Rev 1.2 Added original schematics and checked all connections. fixed one value.  
Rev 1.3 Added the gnd I miees, and fixed the caps.  
Rev 1.4 R5 missing on PCB fixed, LED1&2 a/c switched on other f-board. Power connector turned!!!  
removed unneccessary nets  
Rev 1.4 Fixed the double silkscreen on back of front panel, also fixed cap sizes 100nF

TITLE: TH MI Links clone		REV: 1.1
EasyEDA	Company: Sourcery Studios MIAW	Sheet: 1/1
	Date: 2024-07-02	Drawn By: Kristian Blå sol

TITLE: Sheet_3		REV: 1.0
EasyEDA	Company: Your Company	Sheet: 1/1
	Date: 2024-09-27	Drawn By: Kristian Blå sol

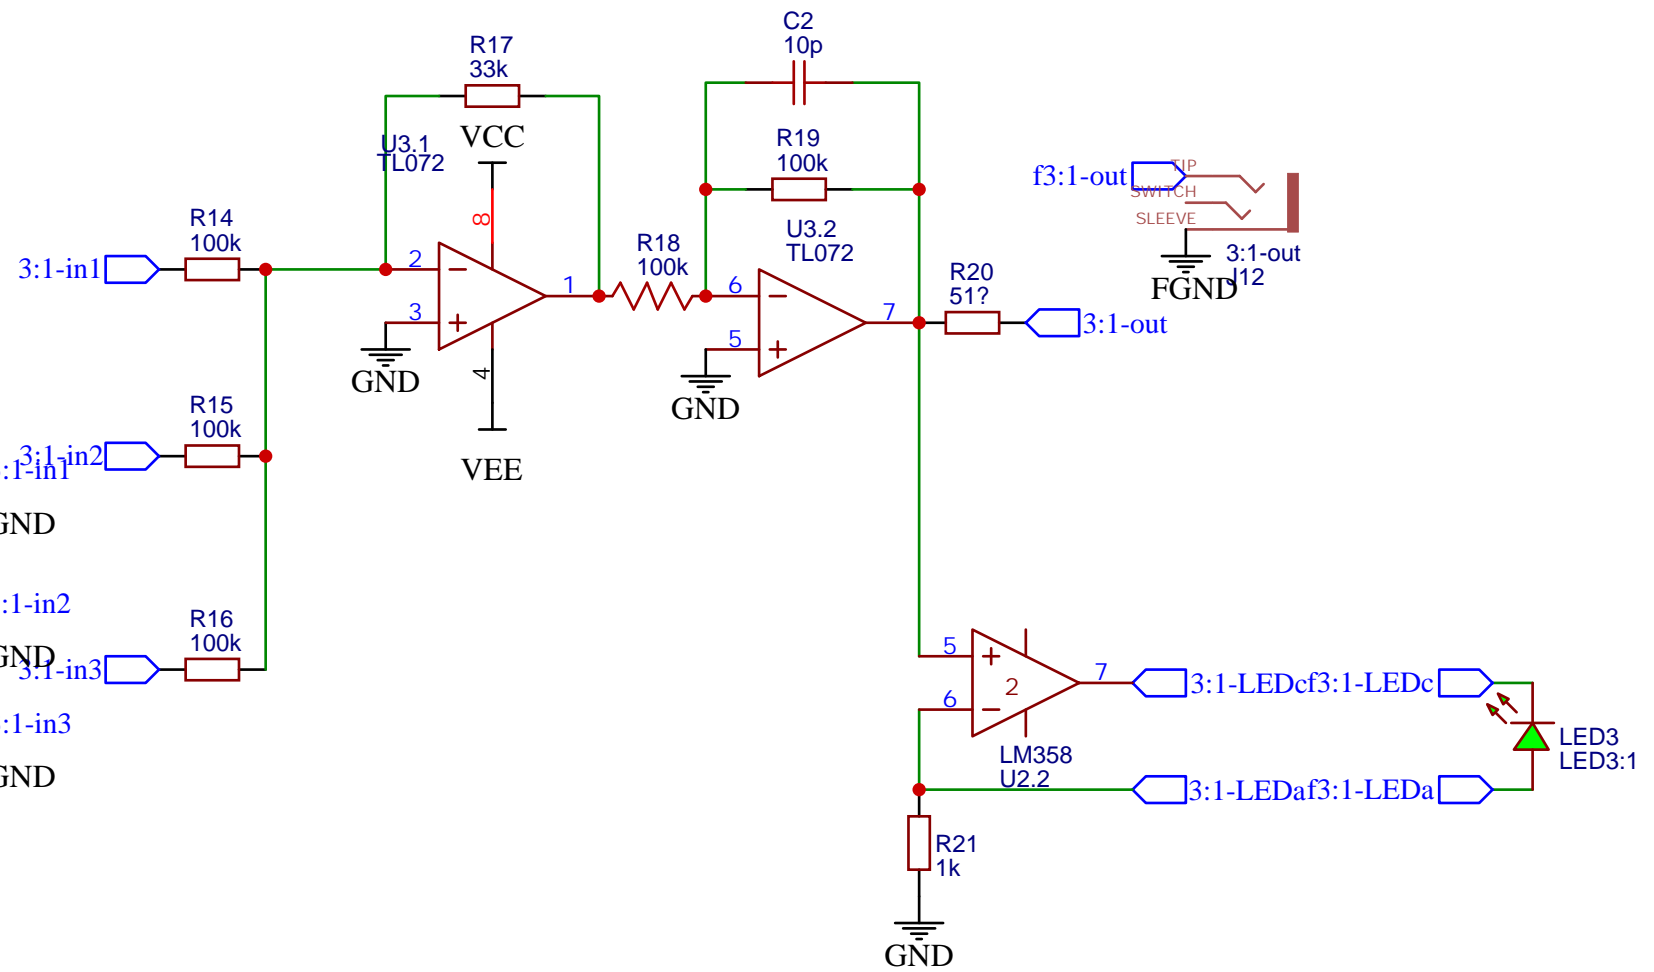
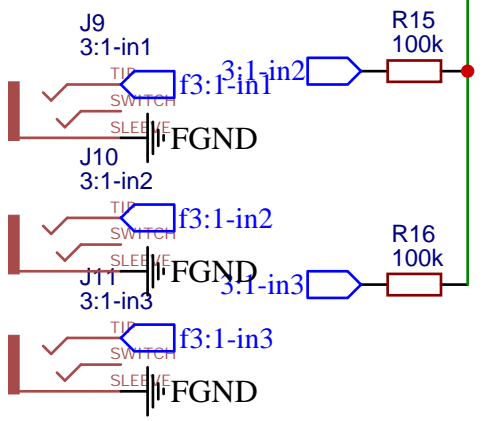
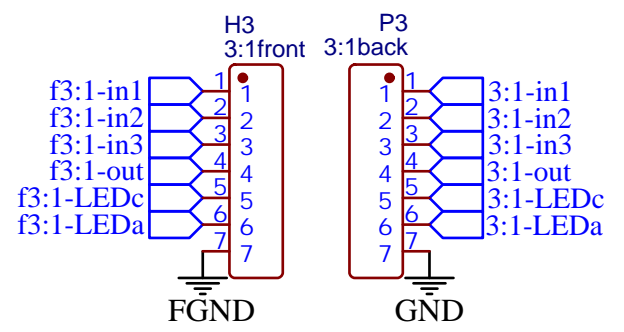
Fixes:  
R15/R17 wrong value -> 33k  
Fixed U4.2 to U3.2
